SUBJECT: COMANCHE PEAK NUCLEAR POWER PLANT, UNITS 3 AND 4
DOCKET NUMBERS 52-034 AND 52-035
SUPPLEMENTAL RESPONSE TO REQUEST FOR ADDITIONAL INFORMATION
NO. 6403 (SECTION 14.3.7) AND 6457 (SECTION 14.2)

RAI NO.: 6403 (CP RAI #254)

QUESTION NO.: 14.03.07-38

RAI NO.: 6457 (CP RAI #257)

Figure 9.2.5-1R Ultimate Heat Sink System Piping and Instrumentation Diagram (Sheet 1 of 2)

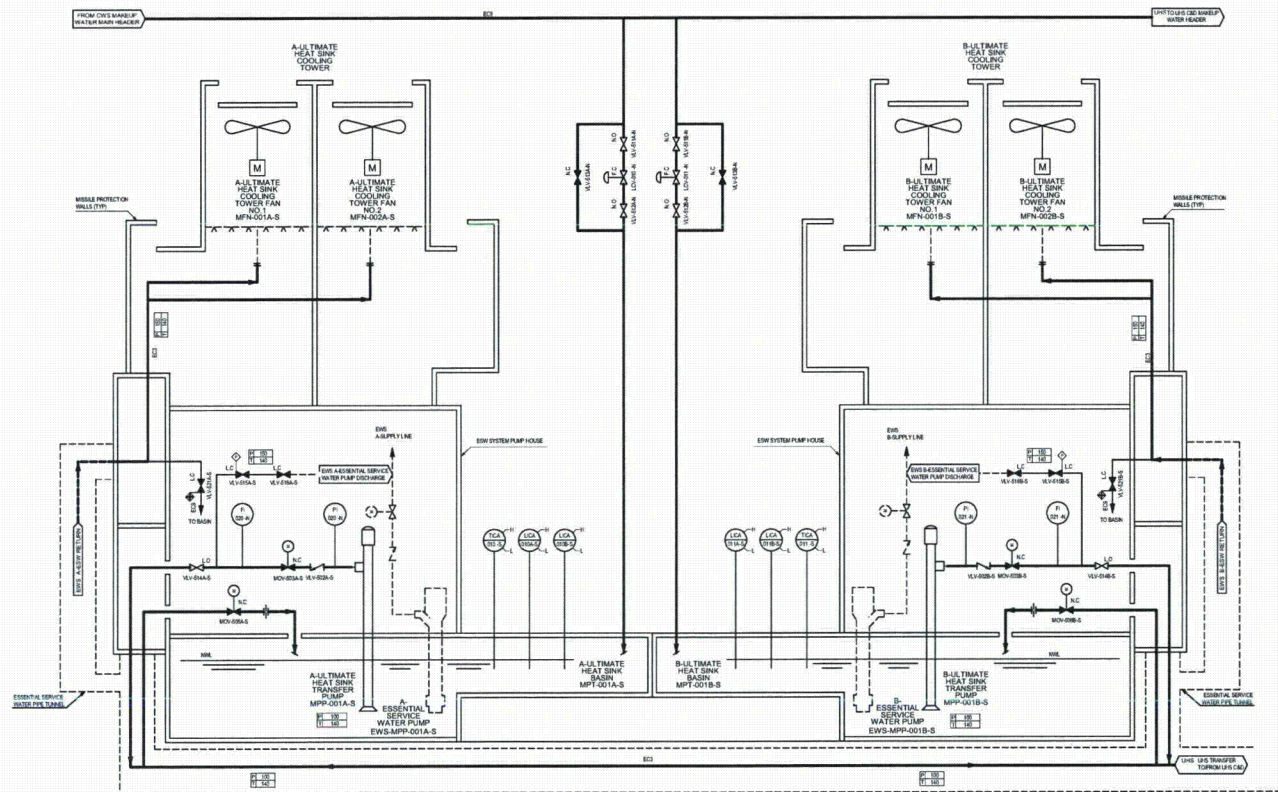
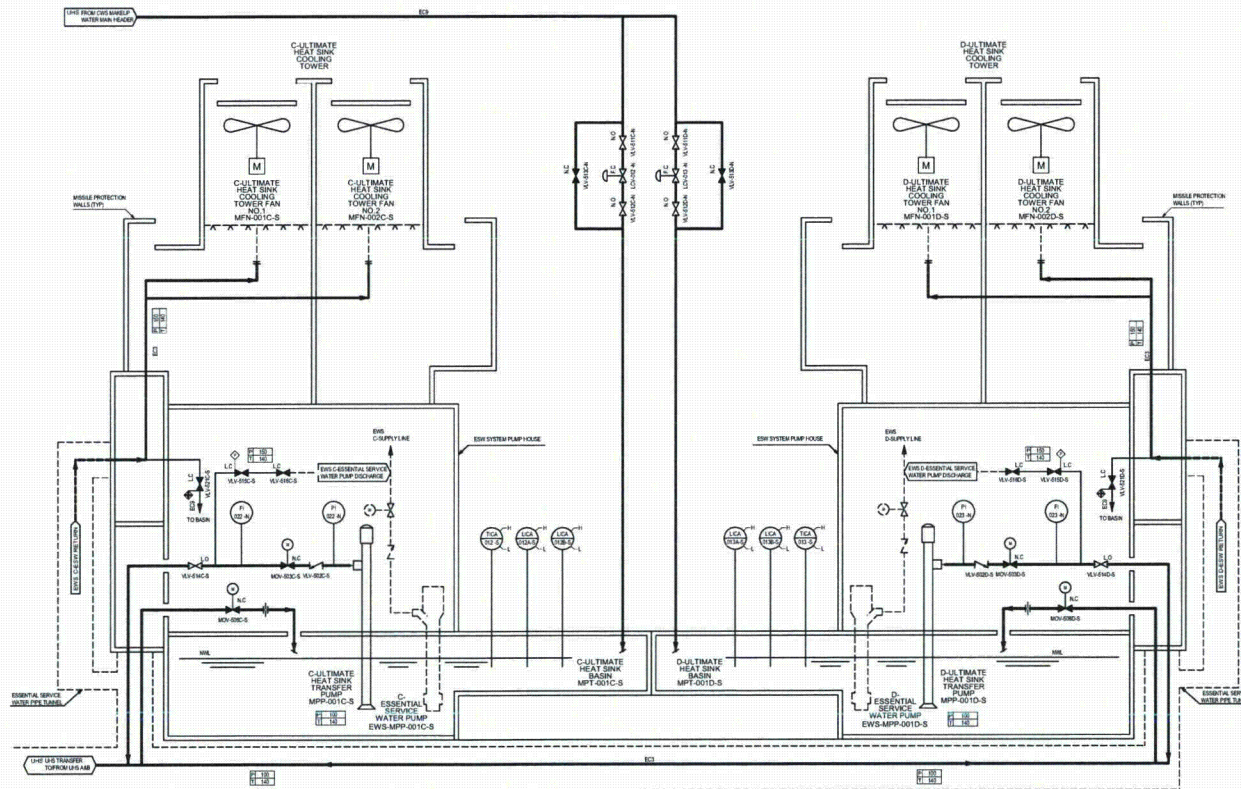
1. Site-specific ITAAC should clearly describe testing of the UHS transfer pumps and associated MOVs from their various safety-related power supplies.
2. Site-specific ITAAC should clearly describe testing of the ESWS/UHS heat tracing.

Table 9.2.5-201 has been added to show the electrical power configuration for the UHS transfer pumps and associated MOVs.

Figure 9.4-201 UHS ESW Pump House Ventilation Systems Flow Diagram

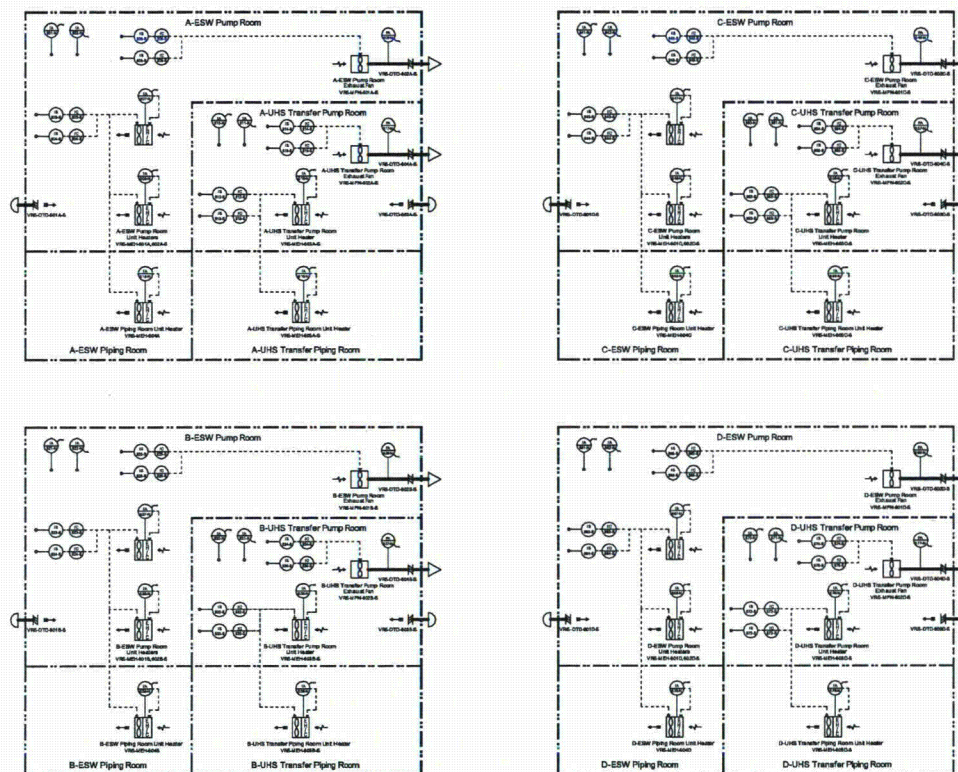
3. Site-specific ITAAC should clearly describe testing of the ESWS/UHS freeze protection features (which may include operating the UHS fans in reverse speed).

2. FSAR Subsections 9.2.1 and 9.4.5 have been revised to address freeze protection for the ESW piping and UHS transfer piping that pass through the piping rooms that are between the pump house and the essential service water pipe tunnel (ESWPT). These piping rooms are heated by unit heaters in the UHS ESW pump house ventilation system, which prevents freezing of the ESW and UHS piping contained therein. Therefore, heat tracing is not applied for freeze protection.

Site-specific inspection and testing for UHS ESW pump house ventilation system is already described in COLA Part 10 Table A.2-1 Item #4. This inspection and testing confirms that the ambient temperature in the piping rooms can be maintained above 40°F by the UHS ESW pump house ventilation system so that ESW and UHS transfer piping within each piping room will not freeze.
